ARTHOUSE
2334 ELLIOTT AVENUE

DESIGN REVIEW
DPD #3012499
JANUARY 10, 2012

ADDRESS: 2334 Elliott Avenue
 DPD PROJECT #: 3012499
 OWNER: 55 Battery, LLC
 APPLICANT: Nicholson Kovalchick Architects

DMR/C 85/65 ZONE TOWER/BASE CONCEPT

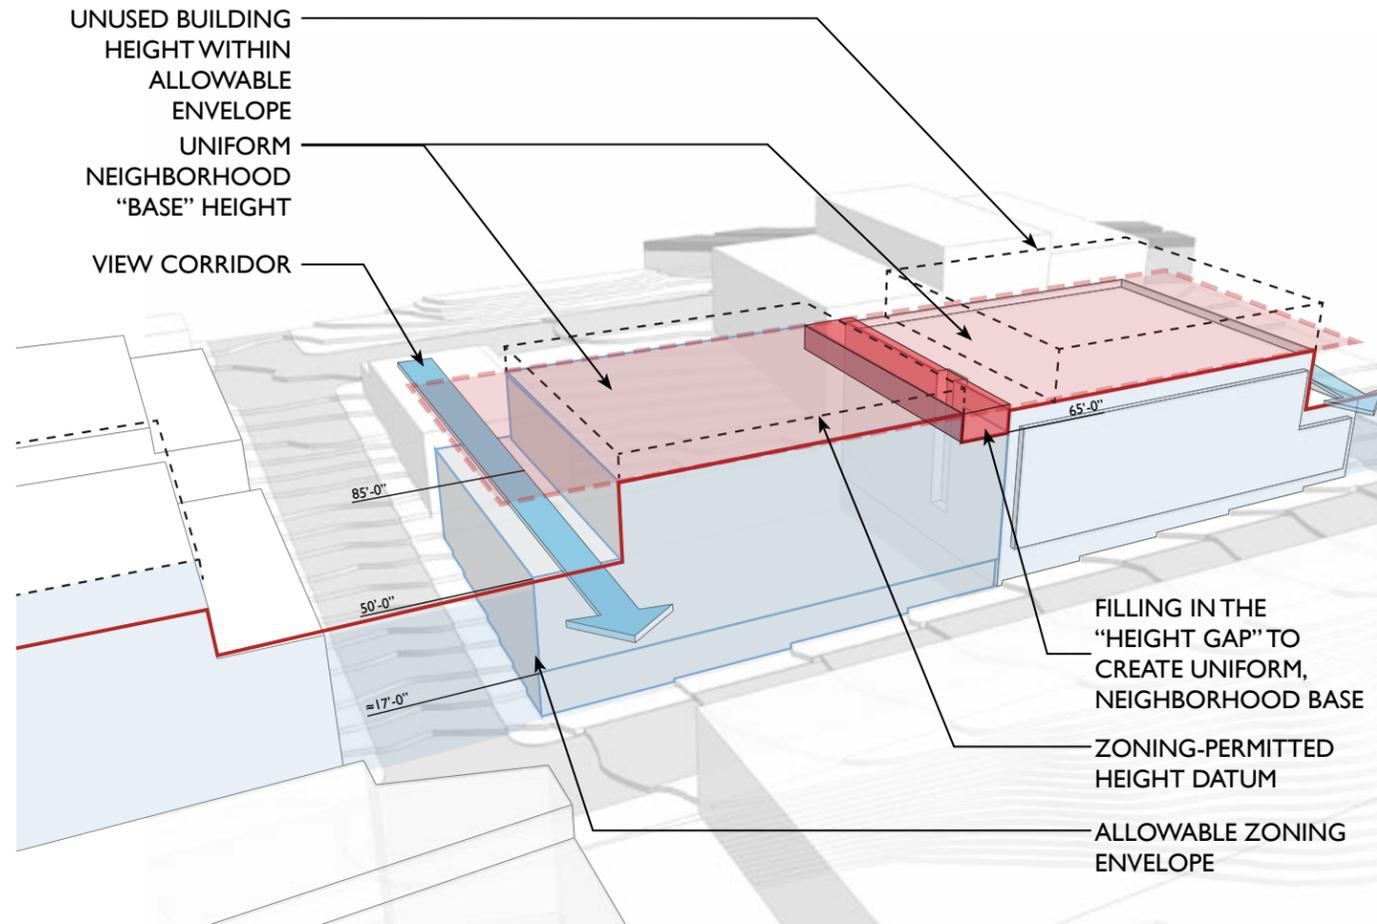
The Board indicated they did not see a design advantage in granting such a departure and were not initially inclined to do so.

The Board indicated because the rationale for this departure is connected to that for the upper level side setback departure, this one also seems to lack merit.

- Reinforce the massing “base” of the neighborhood created by the DMR/C 85/65 zone by filling in the “height gap”
- Reinforce the established building lines with a more consistent and aligned height datum between the proposed building and the existing surrounding buildings.

- If Departure #1 is granted, then the lot coverage for the area between 65’ and 85’ would be 3.7% above the 65% maximum lot coverage

DMR/C 85/65 ZONE VIEW CORRIDOR REQUIREMENTS

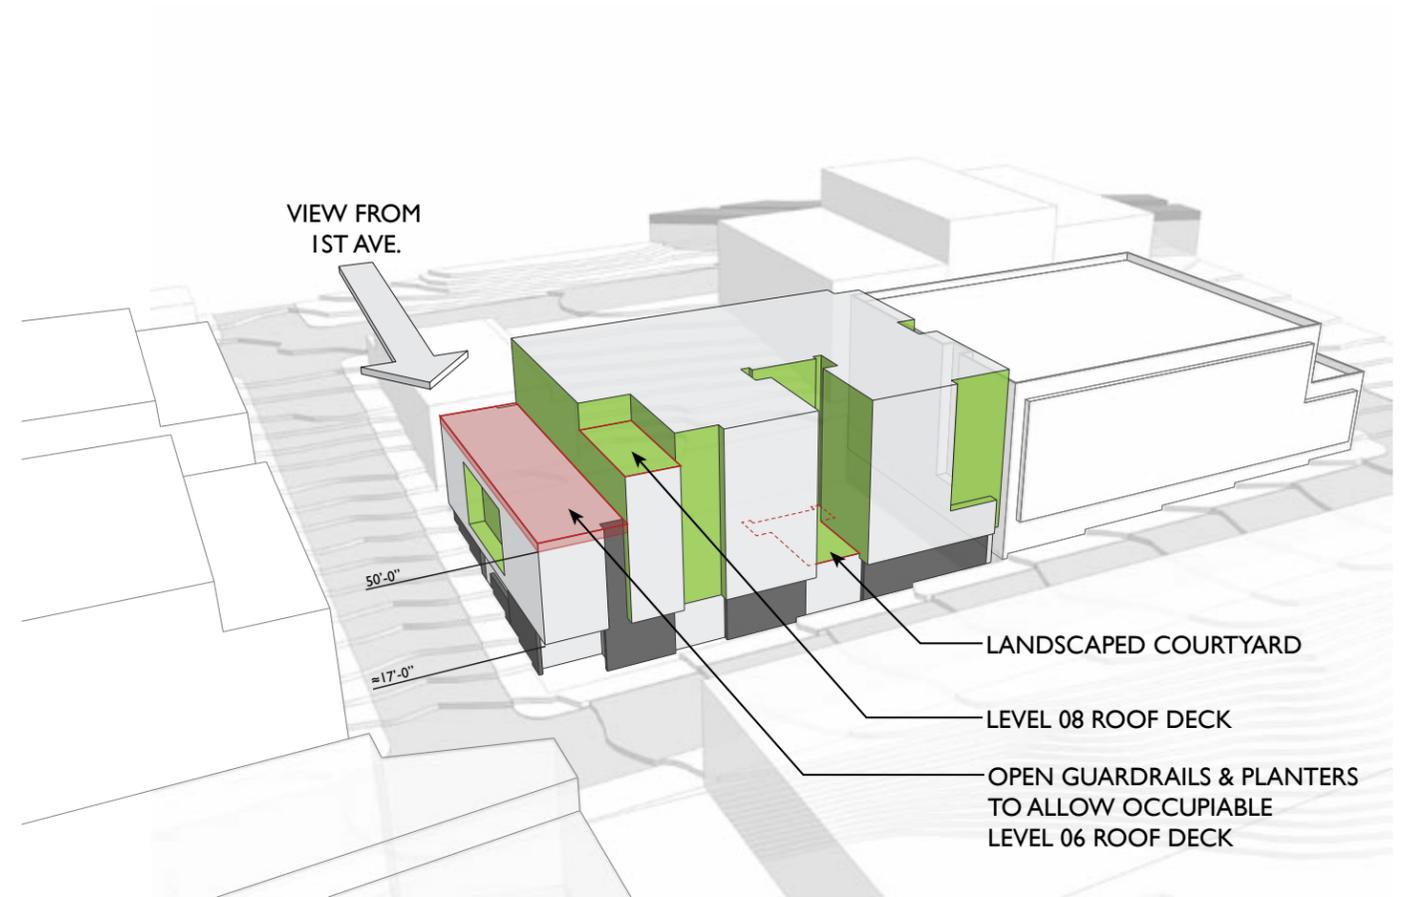
The Board indicated they might be in favor of such a departure where doing so would provide a design benefit such as visible landscape or attractive architectural elements when looking down the view corridor from the east.

The Board indicated they might be in favor of such a departure where doing so would provide a design benefit.

- By allowing vertical railings, planters, and parapets to project vertically into the required view corridor, a common recreation area would be created on Level 06.
- In addition to being a tenant recreation area, the landscaped roof deck would enhance the views looking towards Elliott Bay from 1st Ave. and other uphill areas, enjoyed by both tenants and the surrounding community.
- SMC 23.41.012.B.9 allows “open railings on upper level roof decks or rooftop open space to project into the required view corridor”

- Dependent on Departure #3; not required if Departure #3 is granted.
- If Departure #3 is not granted, then the ratio between enclosed and unenclosed common recreation area would be 1.85/1.

STREETSCAPE PLAN

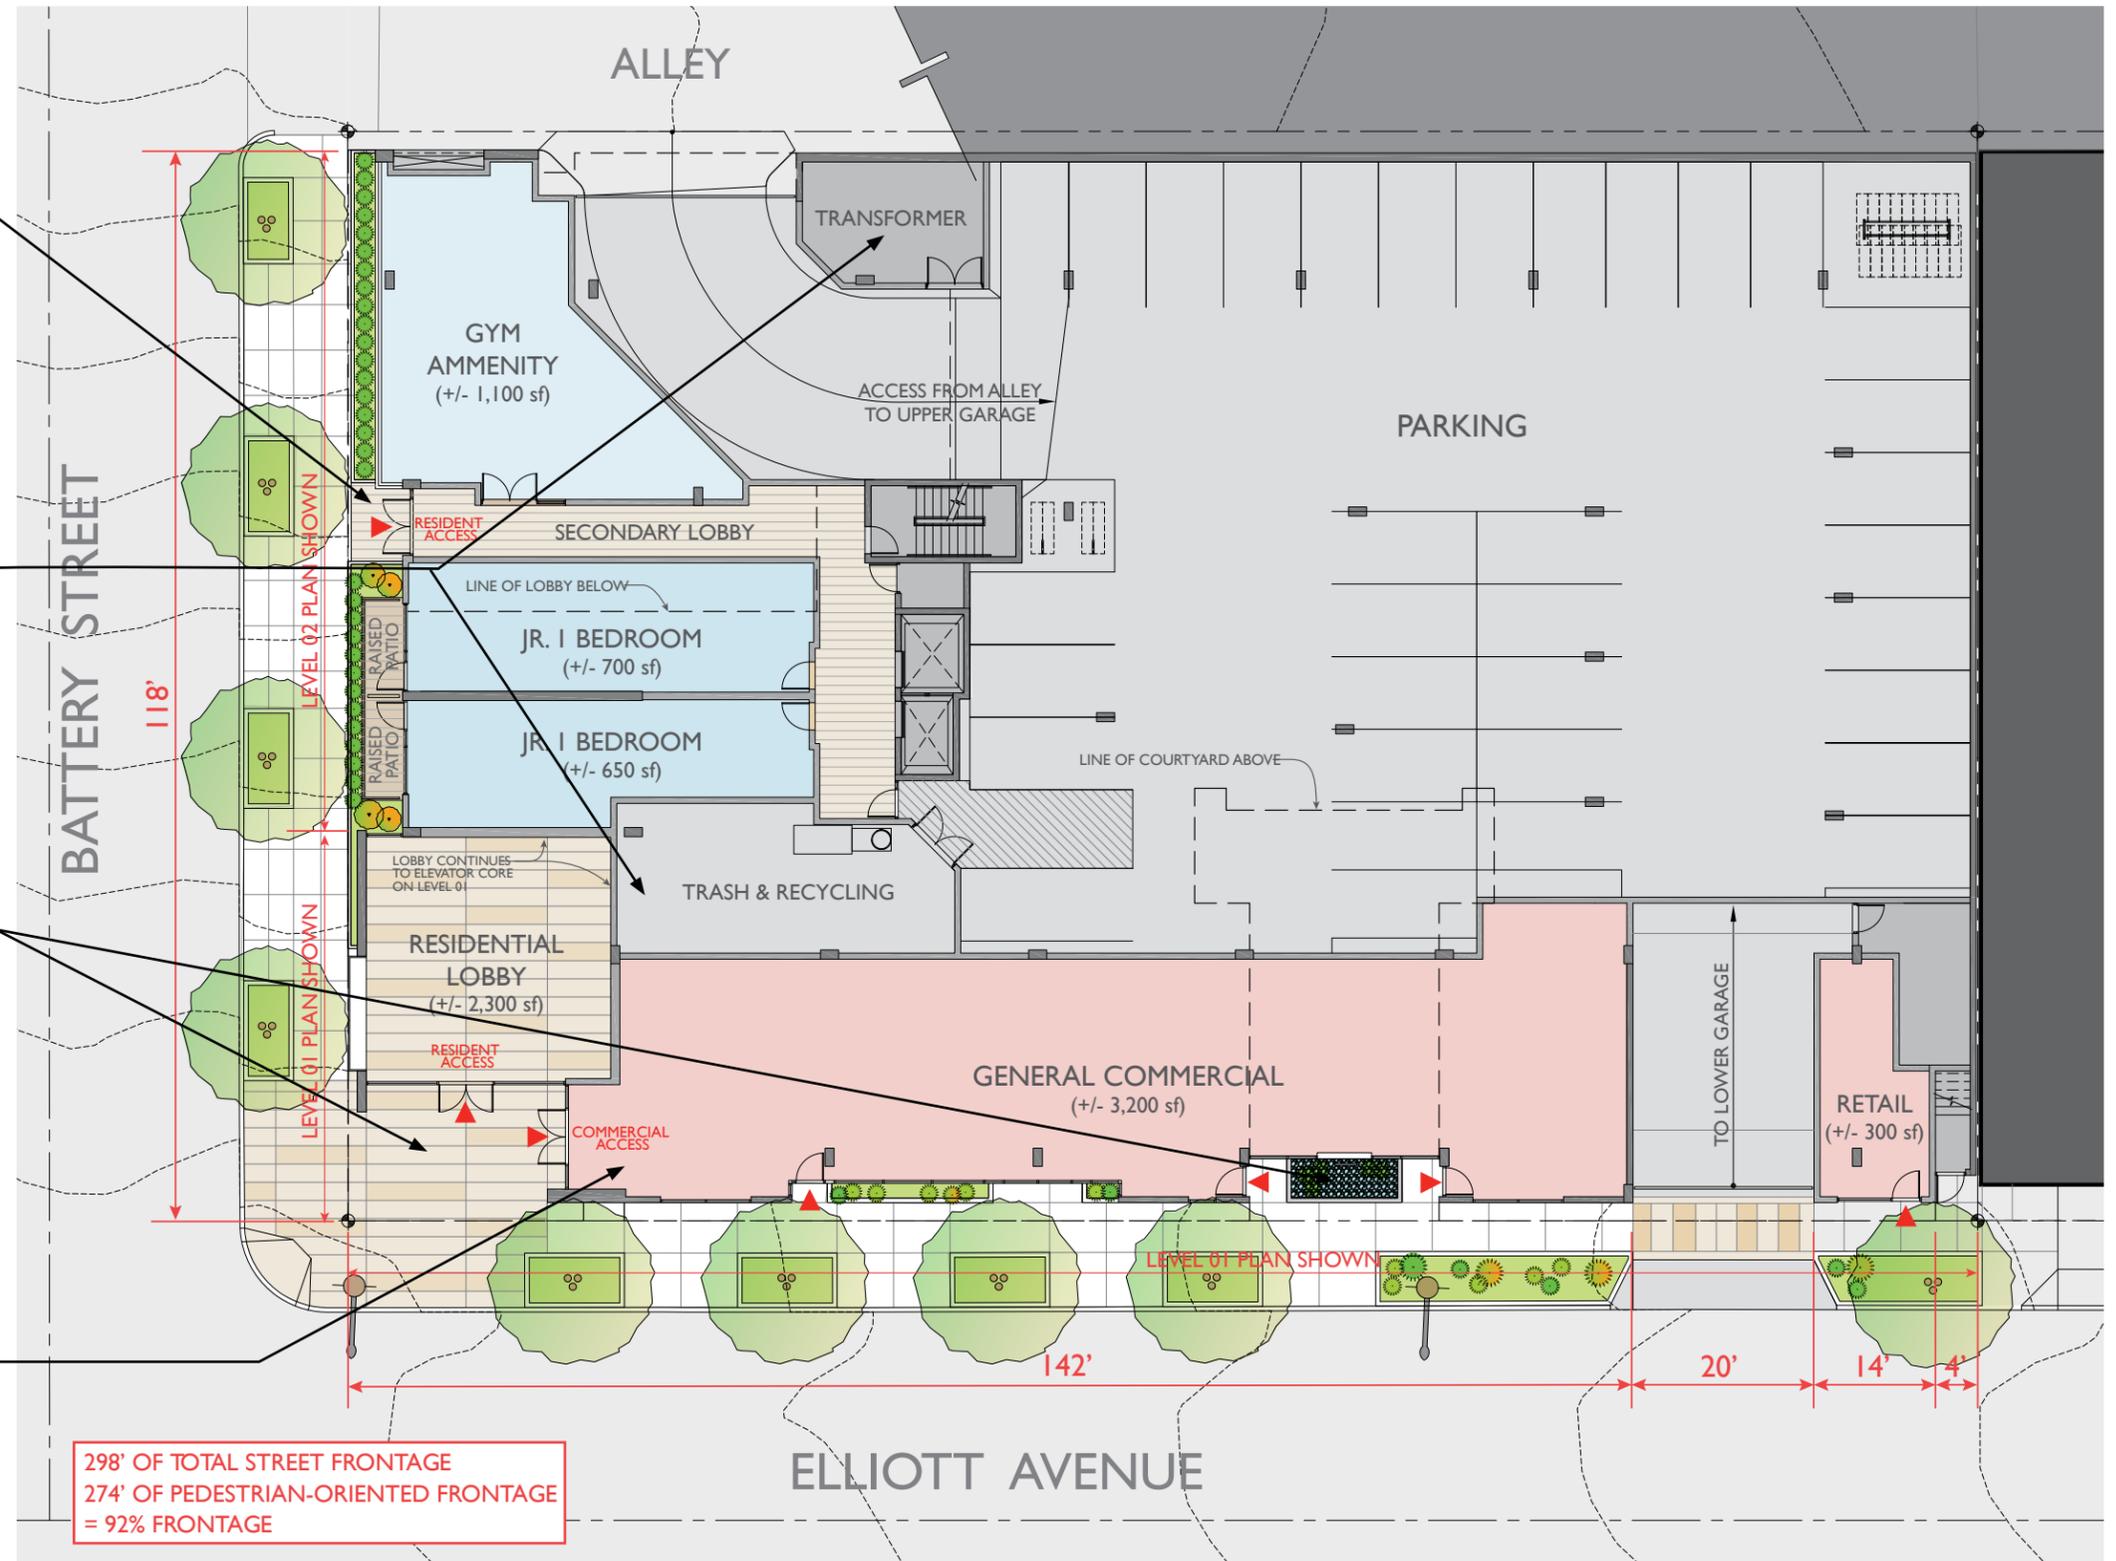
(C-3 & E-3) Provide active, not blank facades & minimize the presence of service areas.
Buildings should not have large blank walls facing the street. Locate service areas away from the street.

In response to comments at the EDG, now all mechanical & utility spaces are now located at the alley or internally within the building and nearly all of the garage is lined with active uses.
